Company	Trenz Electronic GmbH
PCN Number	PCN-20190527
Title	TE0713-01-* to TE0713-02-* Hardware Revision Change
Subject	Hardware Revision Change
Issue Date	2019-05-27

This change affects all Trenz Electronic TE0713-01 SoMs: TE0713-01-\*

### #6 Full update LIB

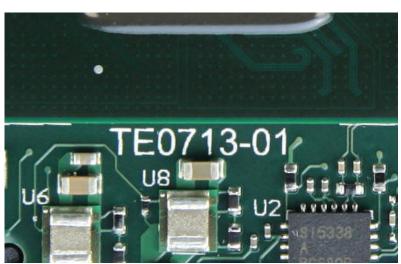
Type: PCB Change

Reason: Improve manufcaturing yield

Impact: None
